ADDENDUM NO. 1
TO THE CONTRACT DOCUMENTS

Date: May 25, 2015
Project No.: 497074

CROSTOWN WATER TREATMENT PLANT IMPROVEMENTS BID #960-B
FAYETTE COUNTY WATER SYSTEM
FAYETTE COUNTY, GEORGIA

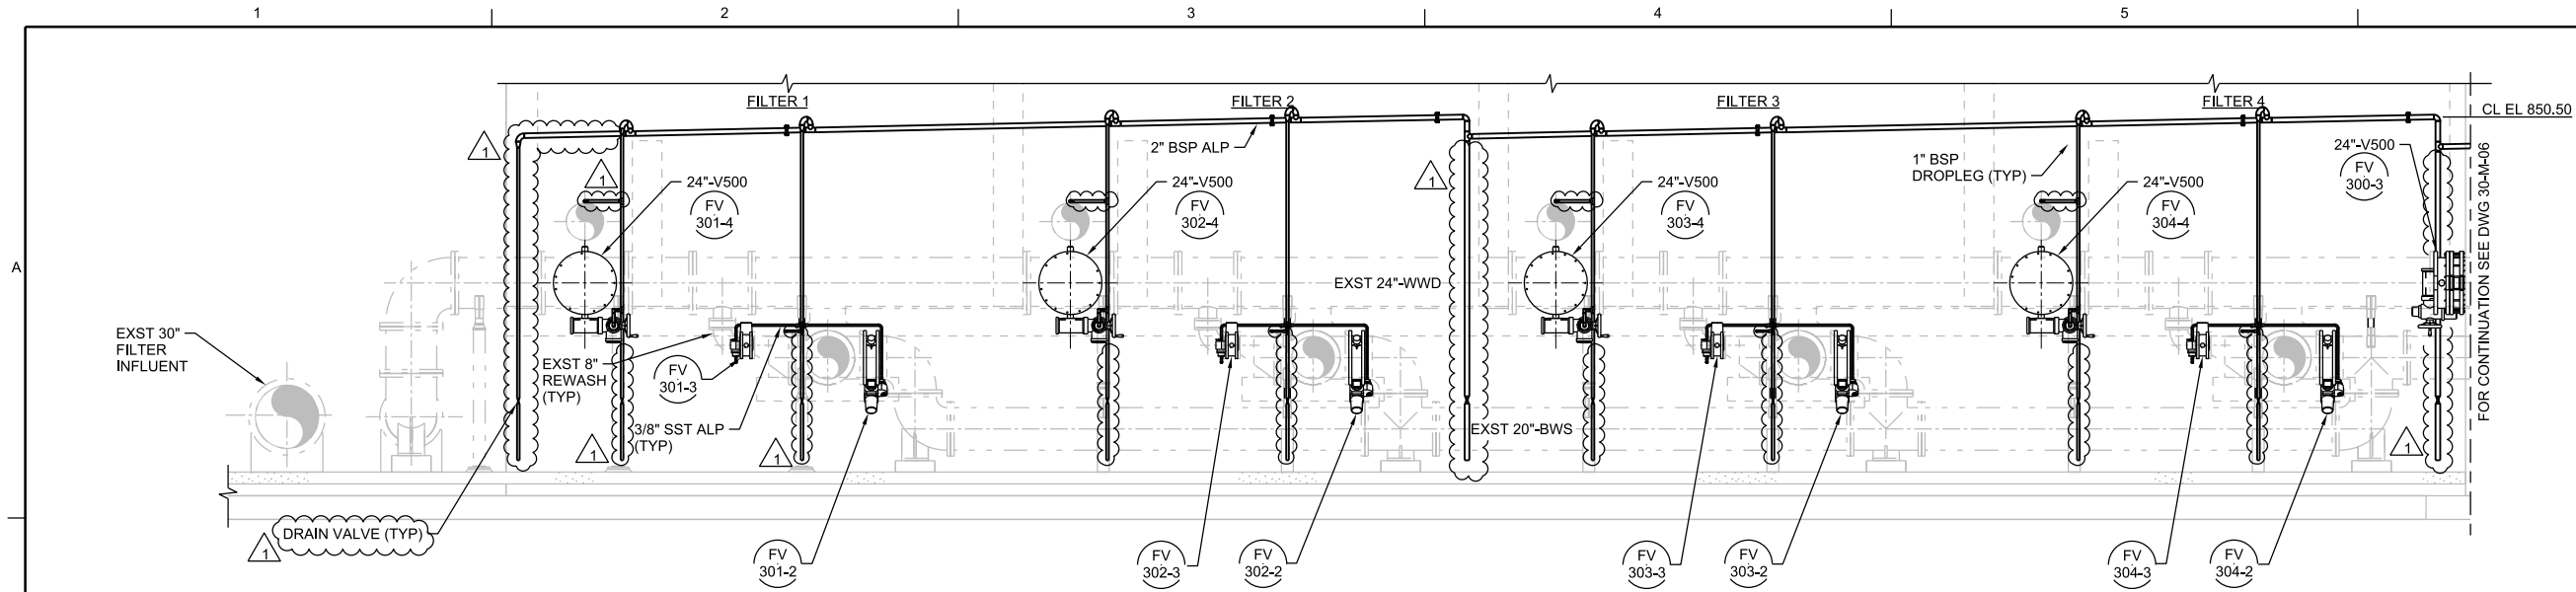
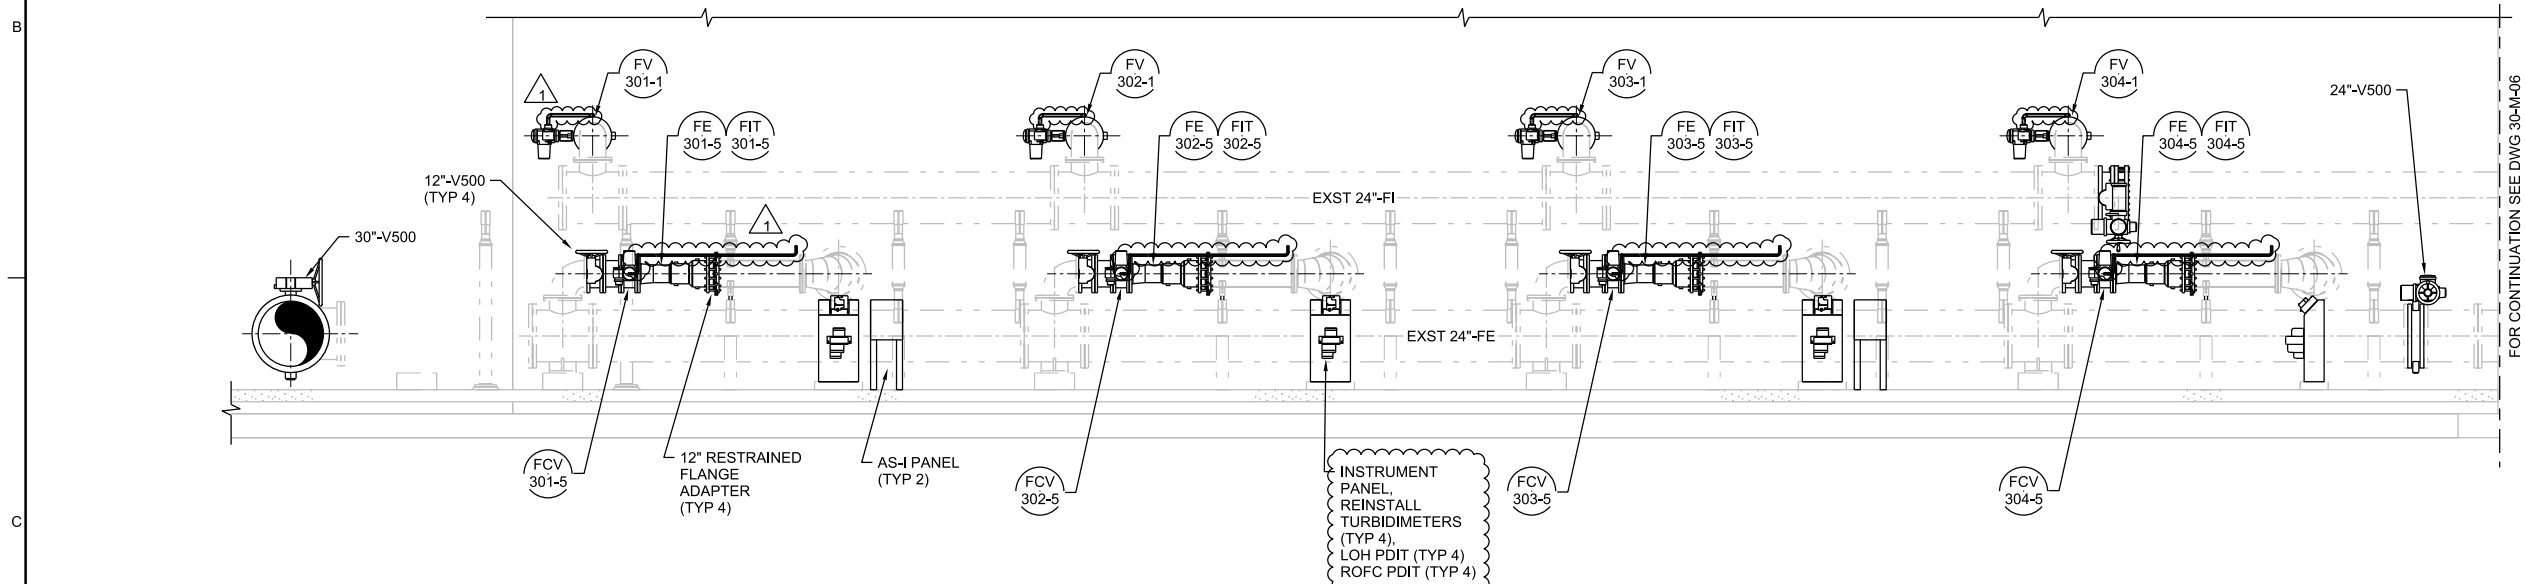
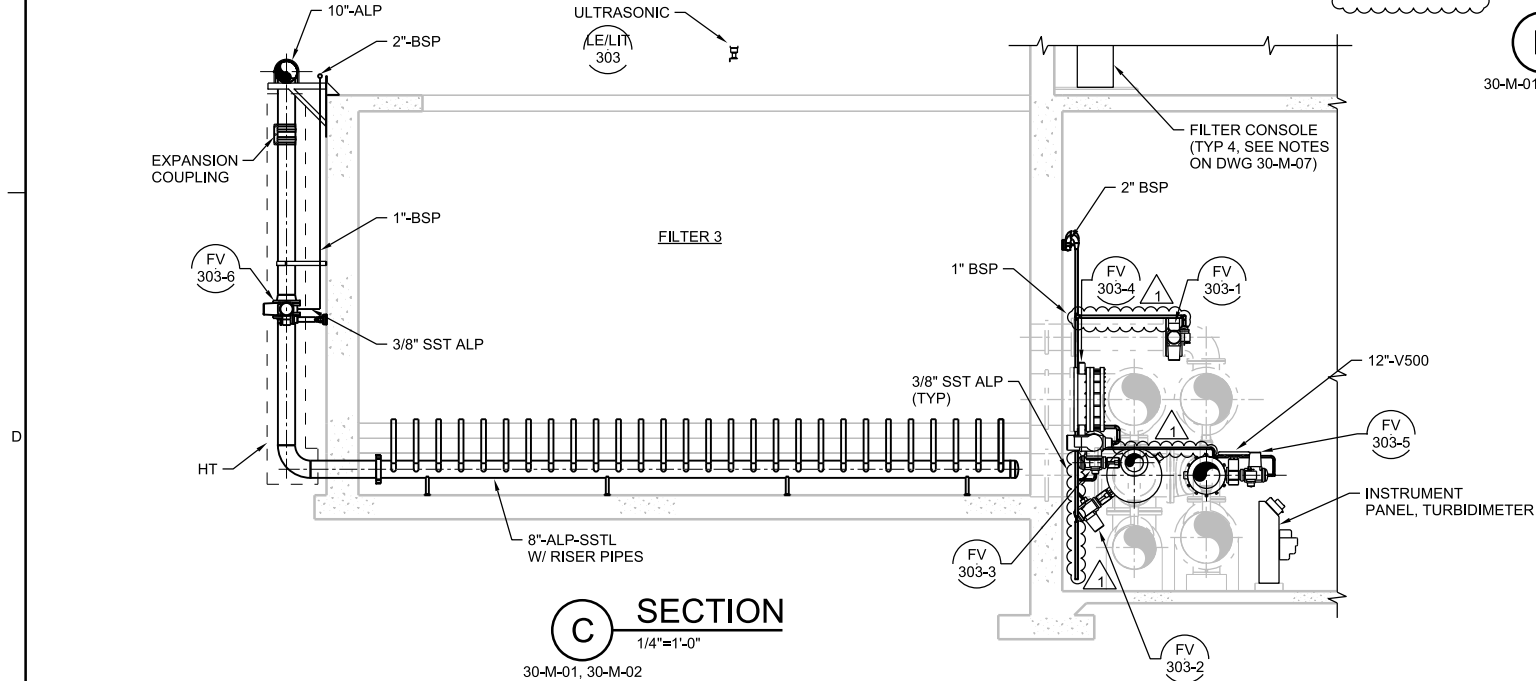
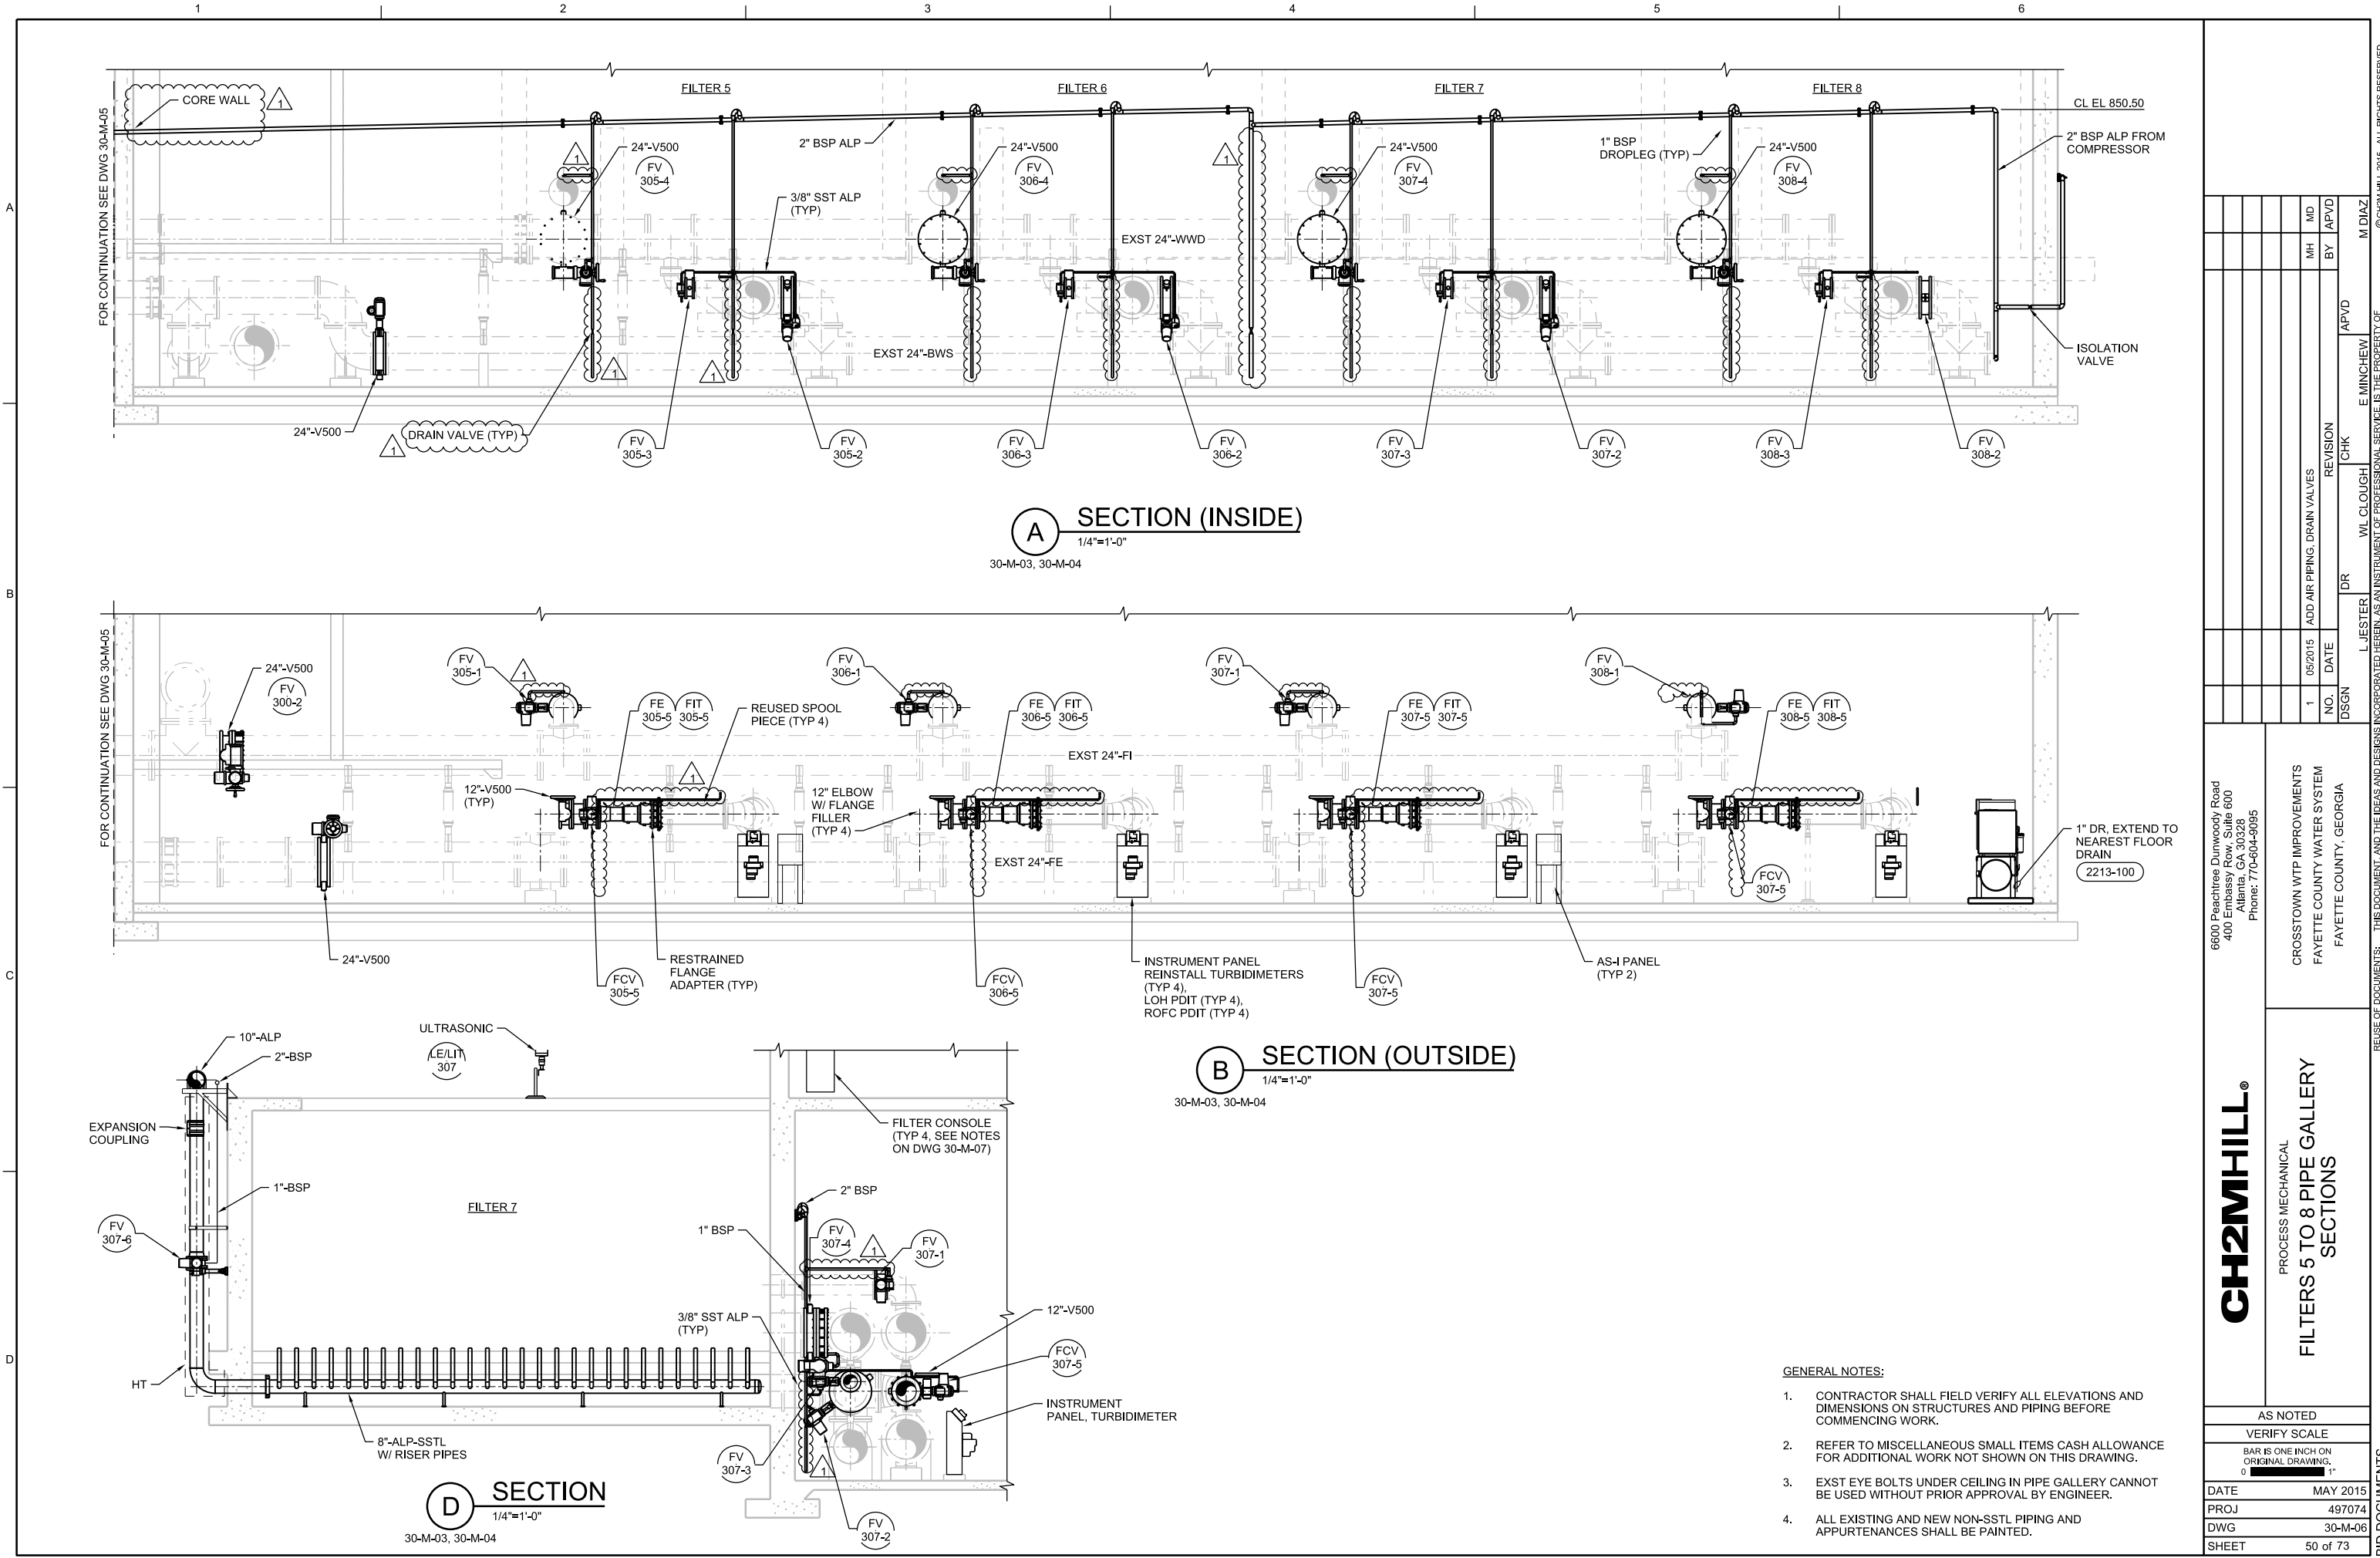
9. Drawing 30-M-04, DELETE in its entirety and REPLACE with revised attached.
